**Title:** Approval of City of Wayzata Granting of Variances from Two City Ordinances for the Construction of a Parking Structure at Barry Avenue and Lake Street East

**Resolution number:** 20-074

The City of Wayzata has been collaborating on a project with three (3) local developers for the last five years to create development sites and public parking. The project entails the redevelopment of three (3) blighted parcels on the northwest corner of the intersection of Lake St. and Barry Ave in Wayzata, MN. The sites are proposed to be developed into an office building, and two separate condominium buildings. The existing and proposed site plans are provided as Attachment B. As part of the project, the northern portion of each of the development sites has been donated to the City to construct a shared parking facility which will consist of the construction of a new, paved, surface parking lot, with the option of constructing a single deck above, in the future.

CITY OF WAYZATA, MINNESOTA  
LAKE ST. / BARRY AVE. PARKING LOT  
STORM SEWER  
PLAN AND PROFILE

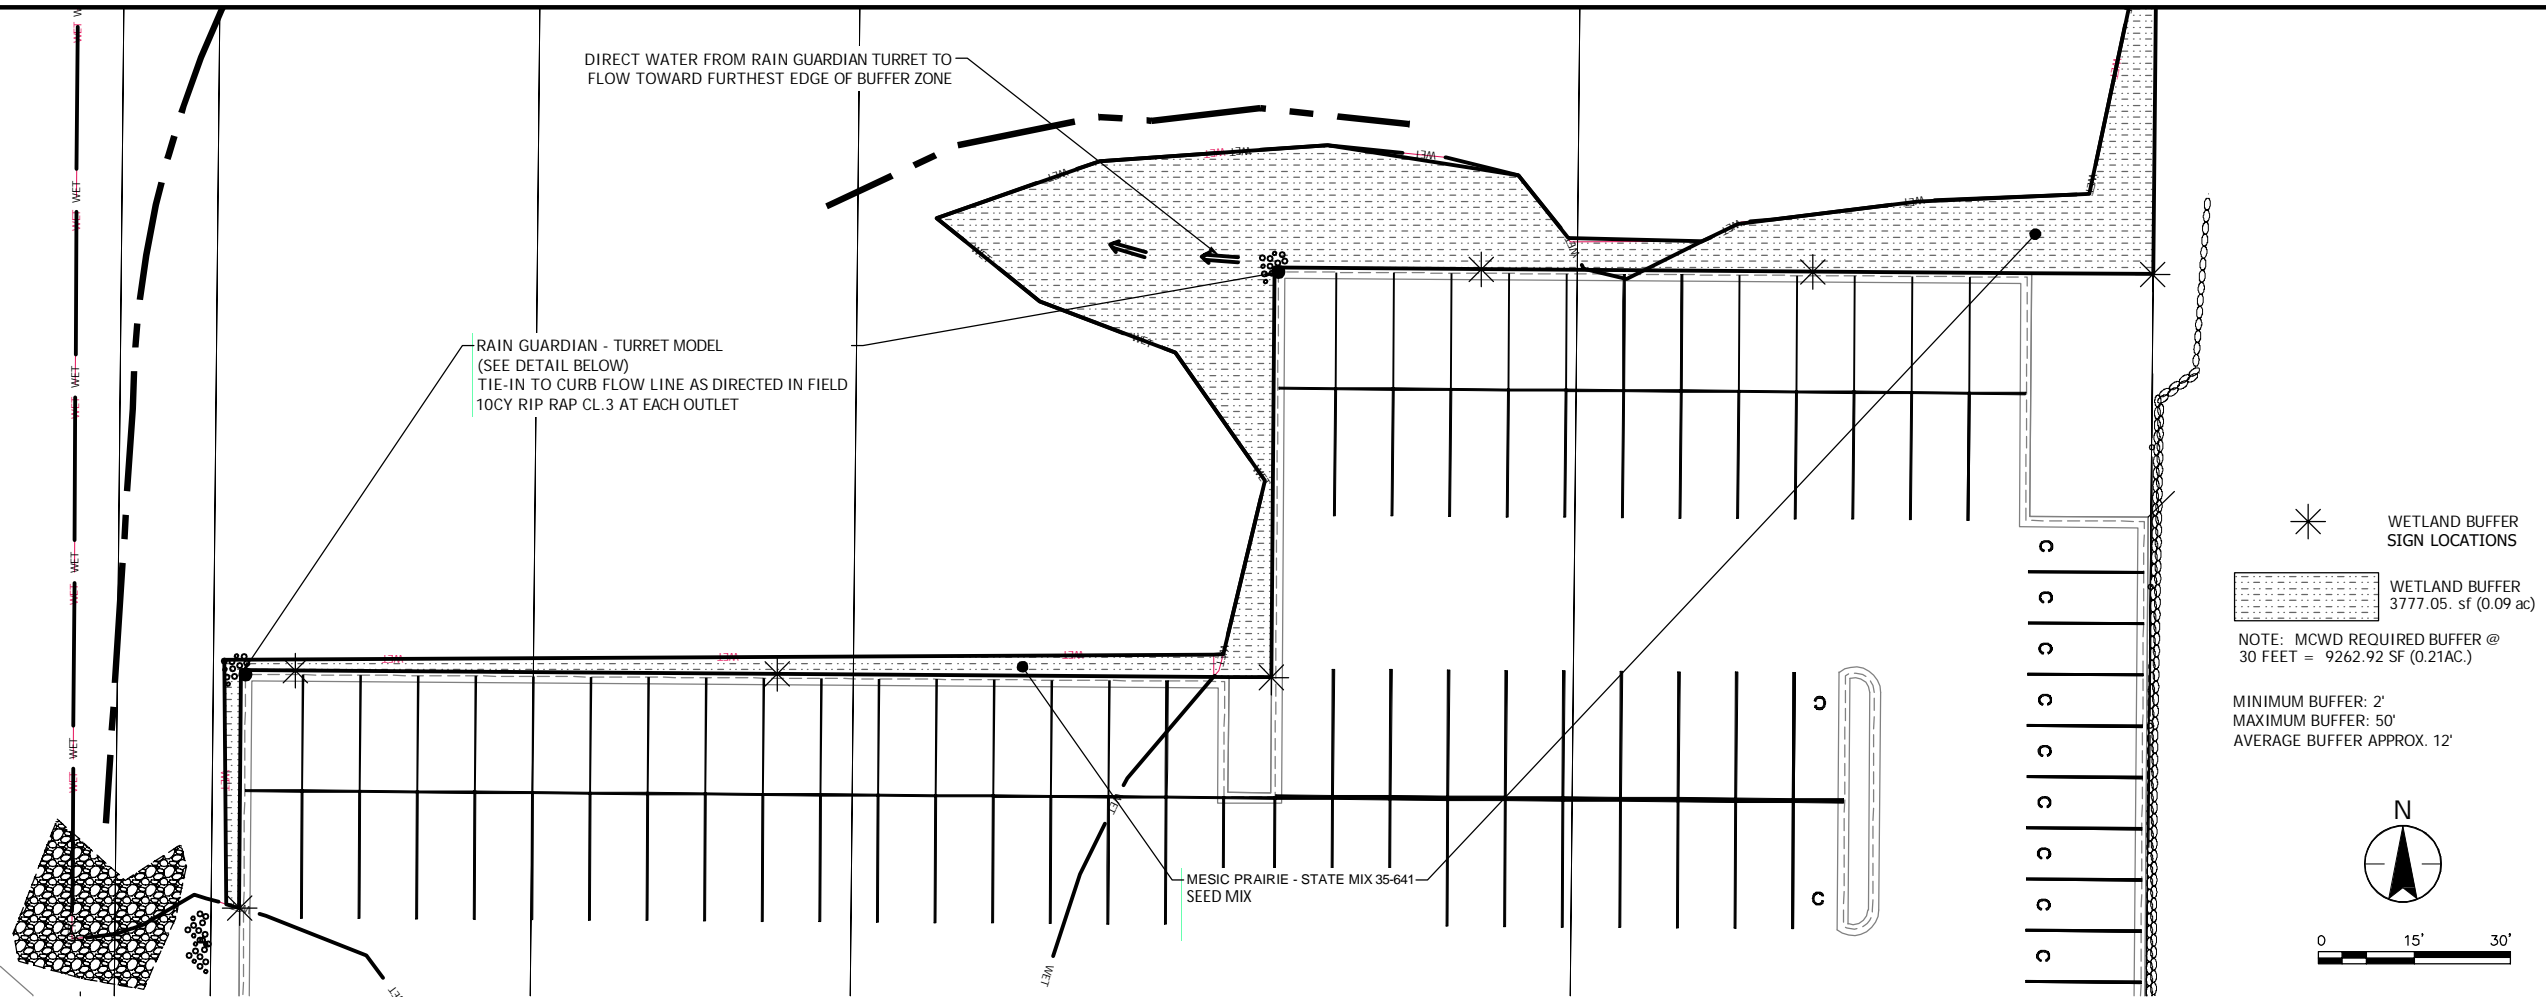
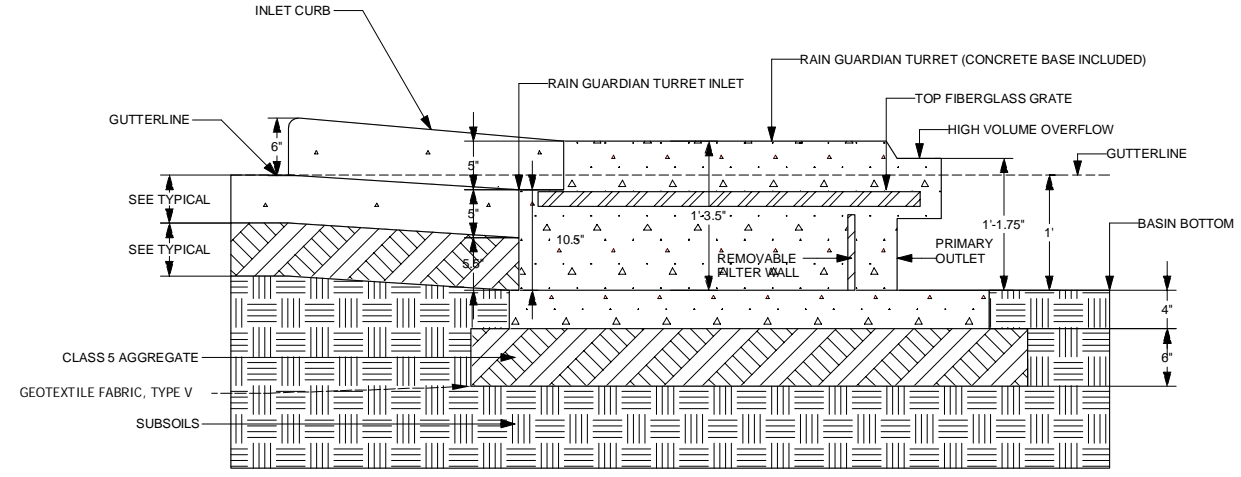
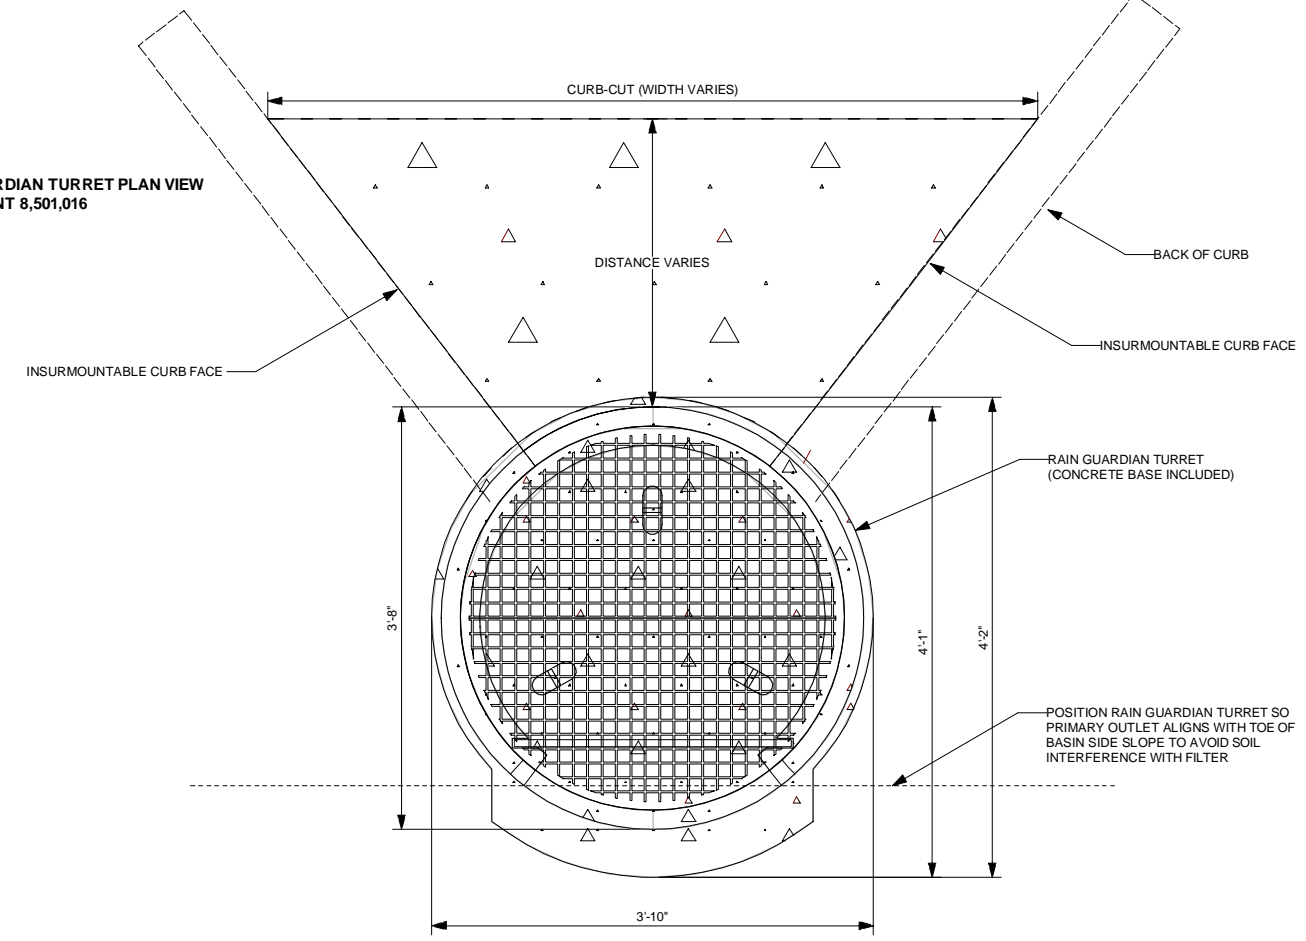
In regards to phosphorous reduction, District Engineers concluded that the submitted 44% reduction is likely not realistic or achievable. The proposed curb and gutter, along with the two Rain Guardian Turrets, will provide a minimum level of nutrient removal (0-5%). Without constructing a stormwater treatment basin within the wetland or raising the proposed grade of the parking lot, however, the District engineer does not believe there are any feasible alternatives to meeting City rate, volume, and phosphorus control requirements.

- Is there a link or reference to published research data that Rain Guardians achieve a 44% TP reduction?

I have attached a link to the product website. They discuss 60-90% sediment removal. I will have Stantec provide how they came up with 44% TP removal.
